PARTS & SERVICE NEWS

REF NO. AA03154

SUBJECT: SERVICE PARTS REVISION FOR PC0700 BLEEDDOWN MANIFOLD

PURPOSE: Correct parts book error

FIGURE 1. BLEEDDOWN MANIFOLD (PC0700)

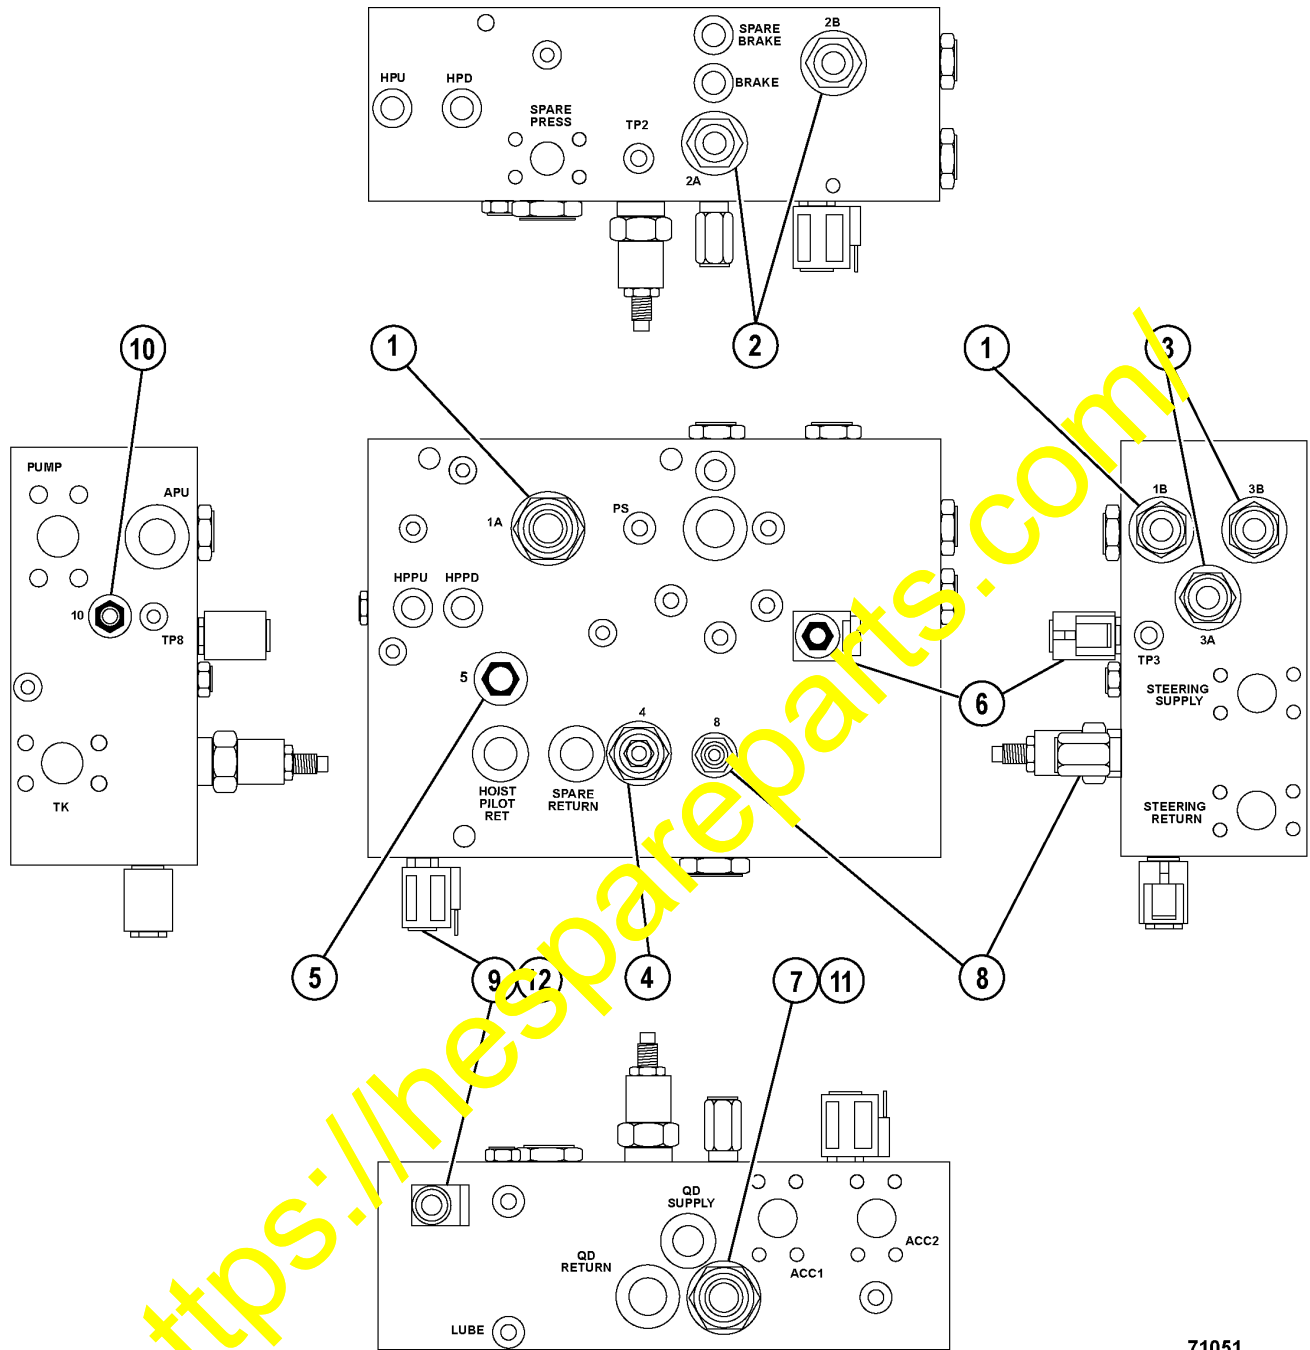
The service parts shown in the parts catalog are incorrect. With the information provided below, please update the service part numbers for PC0700 bleeddown manifolds in all applicable Parts Books.

Service Parts for PC0700 Bleeddown Manifold			
Item Number	Part Number	Quantity	Description
1	PB5916	2	Valve, Check
2	XA0200	2	Valve, Check
3	VE3054	2	Valve, Check
4	VE3833	1	Valve, Relief
5	XA0201	1	Plug, Cavity
6	BF5207	1	Valve, Solenoid
7	VF3830	1	Valve, Check
8	BF5202	1	Valve, Relief
9	VS7009	1	Cartridge
10	BF5204	1	Valve, Pilot Operated
11	XA2379	1	Piston, Pilot
12	XA0202	1	Coil, 24V
